THM 4L60-E/4L65-E "UPDATE HANDBOOK"

AUTOMATIC TRANSMISSION SERVICE GROUP

THM 4L60-E/4L65-E

PREVIOUS "SKF" INPUT SPRAG

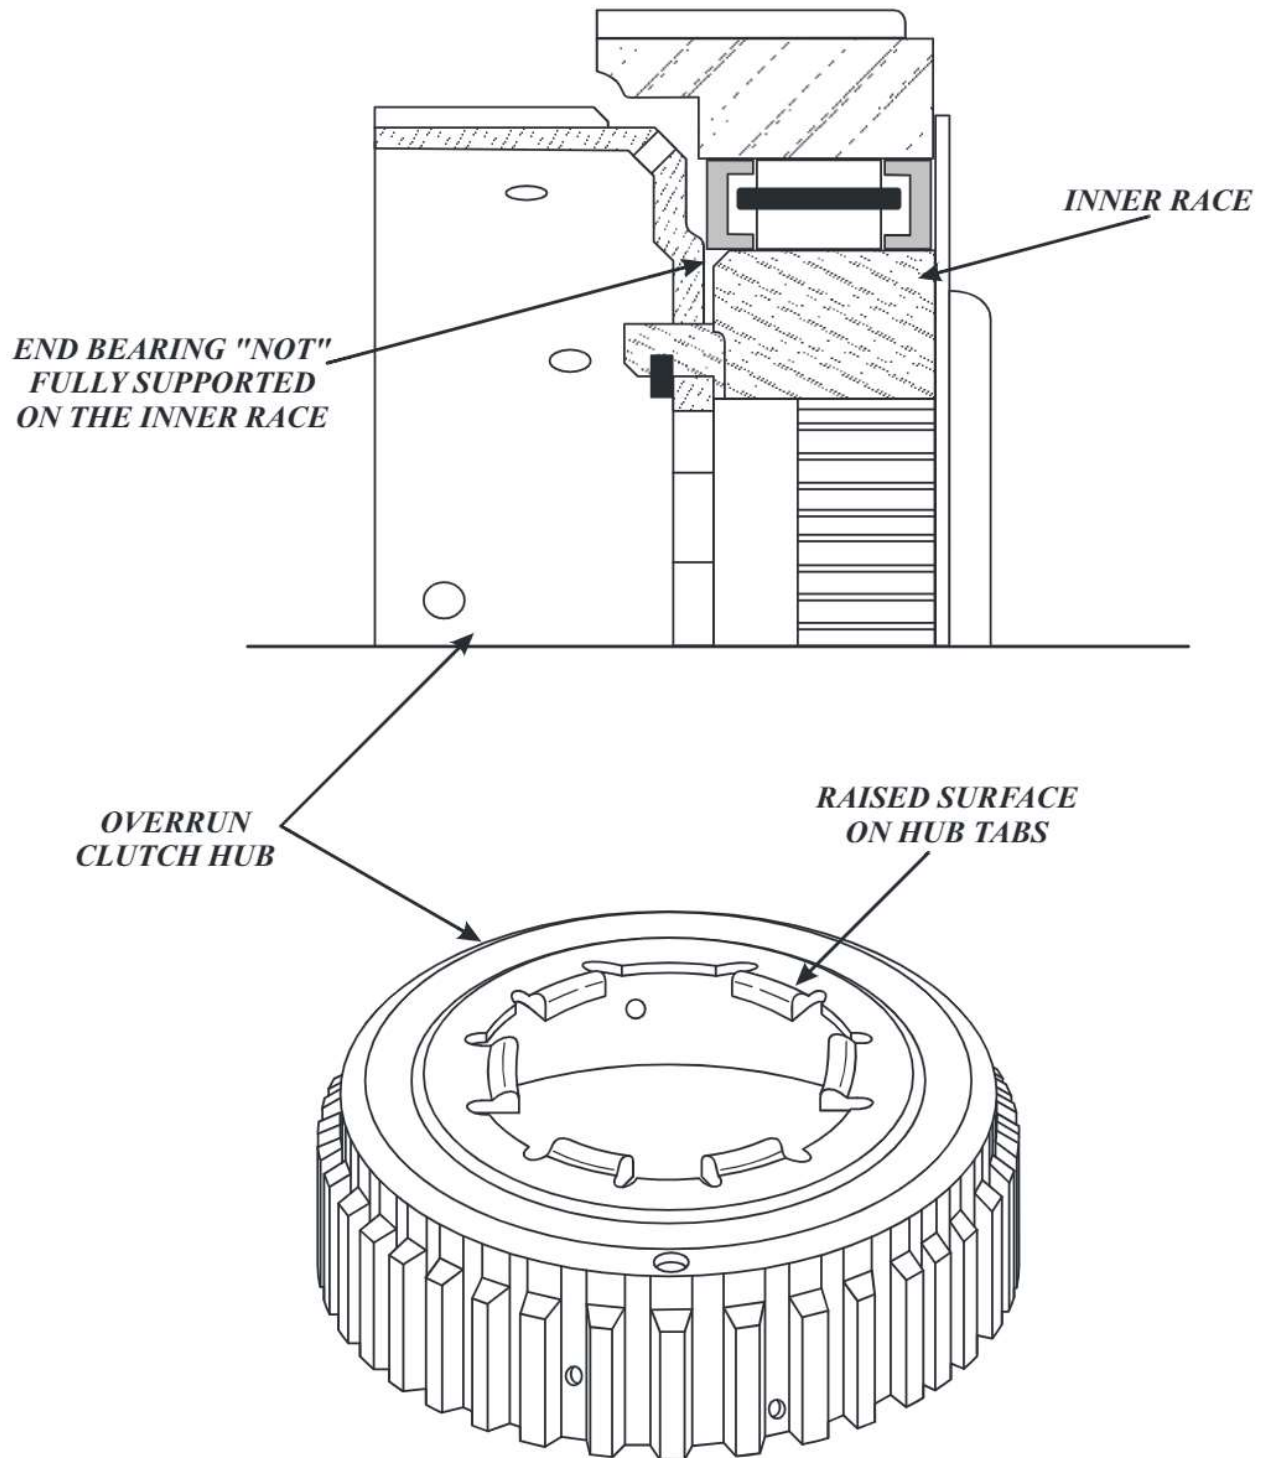
- (1) FORWARD SPRAG INNER RACE - Dimensional changes on the new design inner race, with the removal of the chamfer, and now fully supports the sprag end bearing, on the end bearing inside diameter. Compare the previous cutaway illustration in Figure 2, with the current cutaway illustration in Figure 3.
- (2) OVERRUN CLUTCH HUB - Dimensional changes on the new design clutch hub, with the elimination of the raised tabs on the teeth. The back side of the clutch hub is now flat, to keep the end bearing inside diameter fully on the inner race. Compare the previous clutch hub illustration in Figure 2, with the current clutch hub illustration in Figure 3.

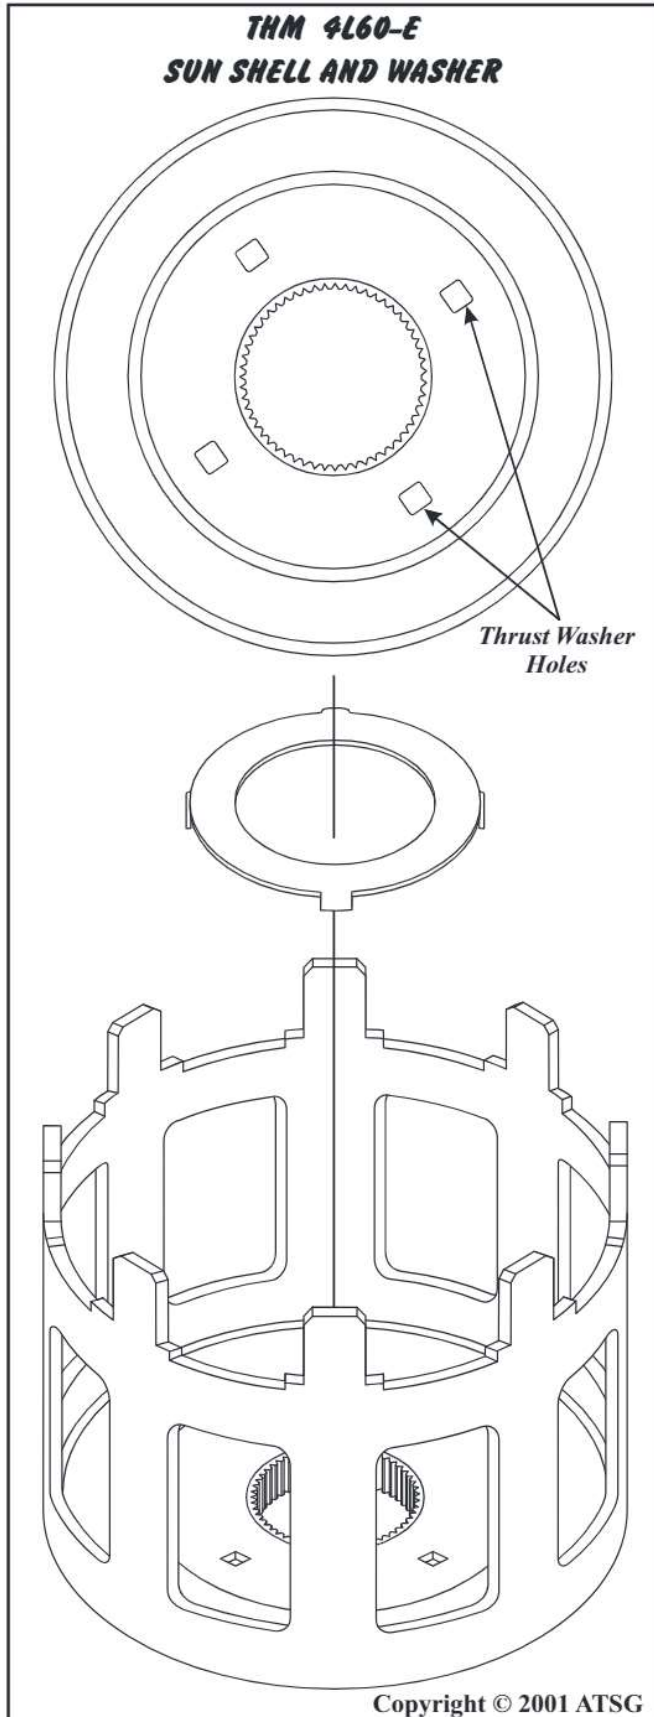
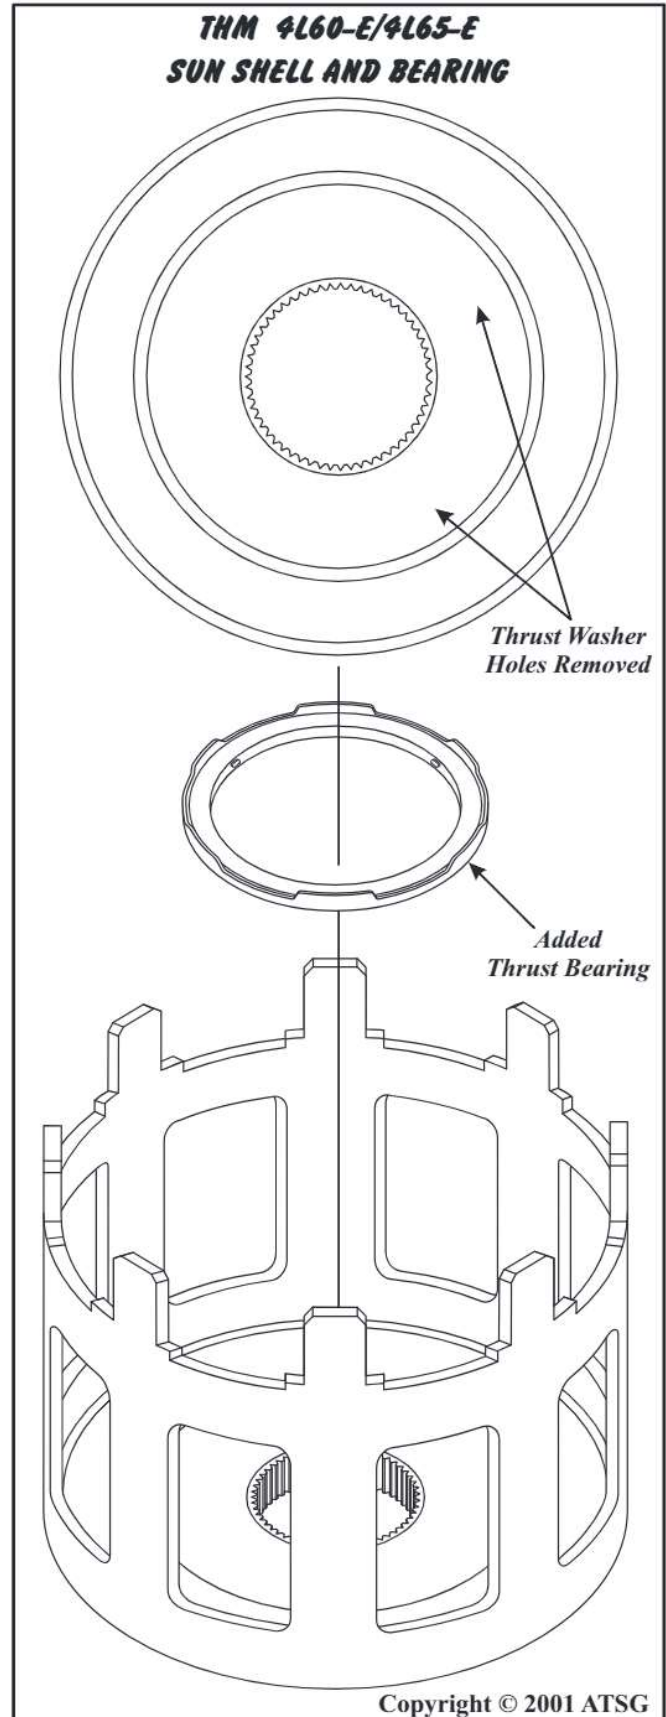
- (1) SUN GEAR SHELL - The holes in the sun shell for the previous thrust washer have been eliminated, as shown in Figures 1 and 2, to accommodate the new thrust bearing.
- (2) REACTION CARRIER SHAFT - Modified on the rear surface to accommodate the added thrust bearing, as shown in Figures 3 and 4.
- (3) THRUST BEARING - Added for increased durability, as shown in Figures 3 and 4.

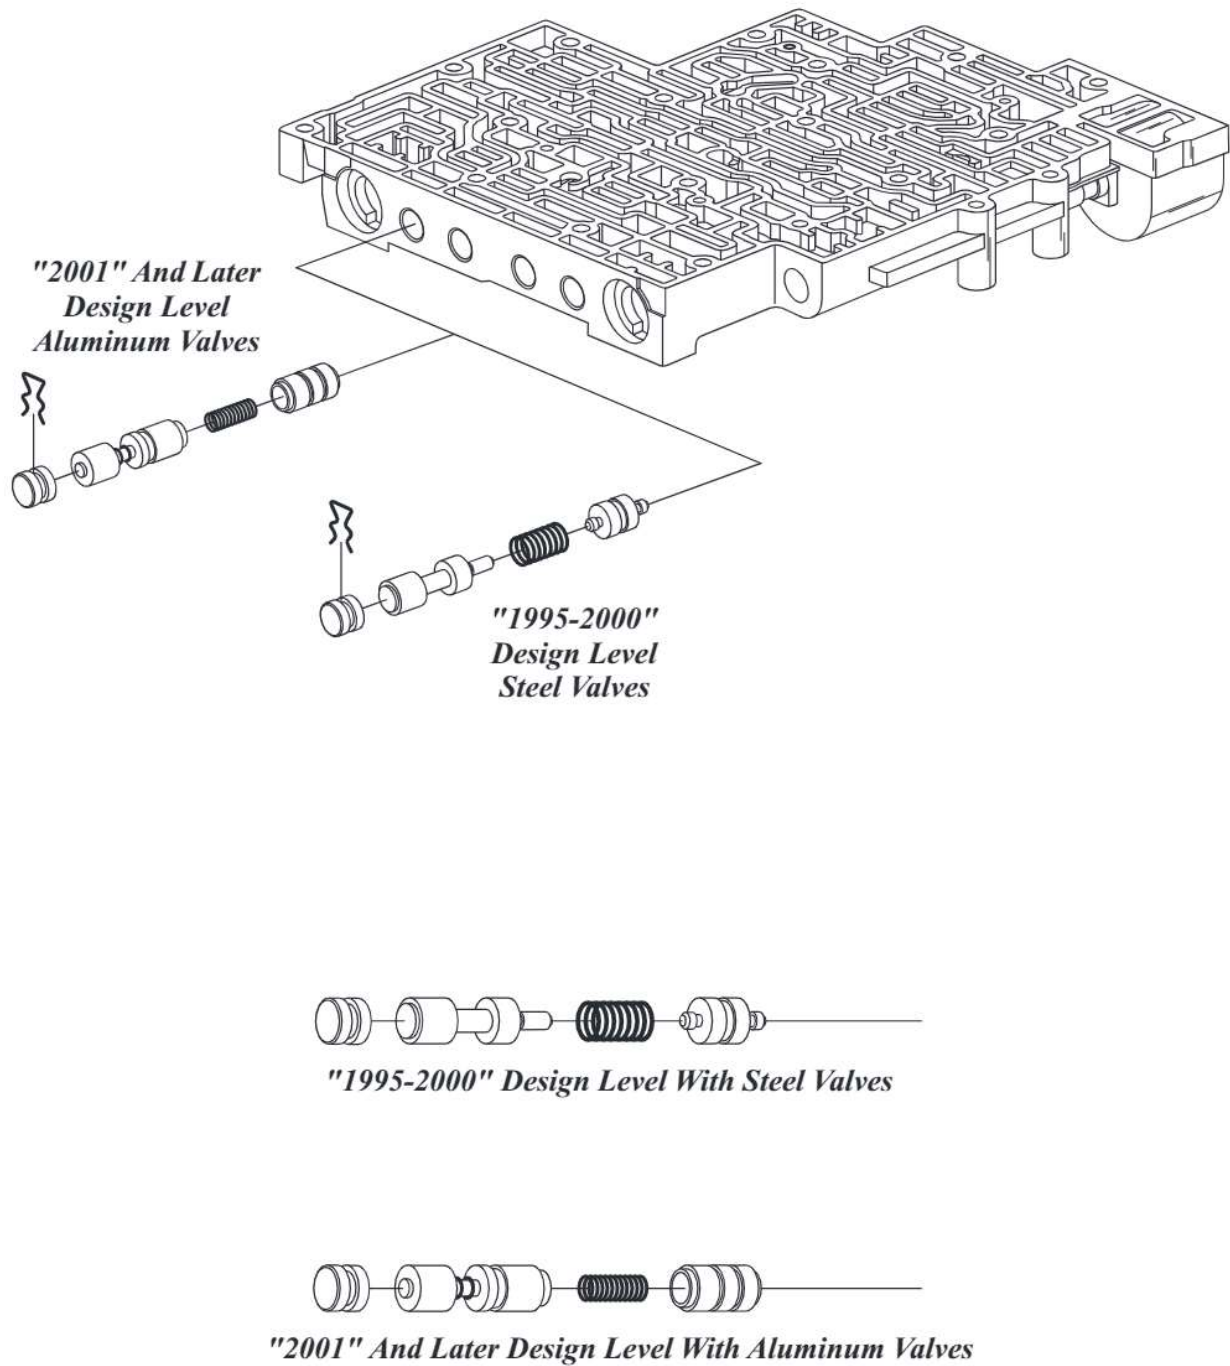
CHANGE: Beginning at the start of production for 2001, all 4L60-E transmissions were produced with a new design converter clutch regulator valve line-up located in the valve body, in the location shown in Figure 1.

- (1) TCC REGULATOR AND ISOLATOR VALVES - This line-up now has re-designed aluminum TCC Regulator Valve and Isolator Valves, instead of the previous steel, as shown in Figure 1.
- (2) VALVE BODY CASTING - Has changed in the worm track areas that are identified inside the circles, as shown in Figure 2, to accommodate the new design converter clutch regulator and isolator valves.
- (3) SPACER PLATE - There are two holes in the spacer plate that have been revised, as shown in Figure 3, to accommodate the new design converter clutch regulator and isolator valves.
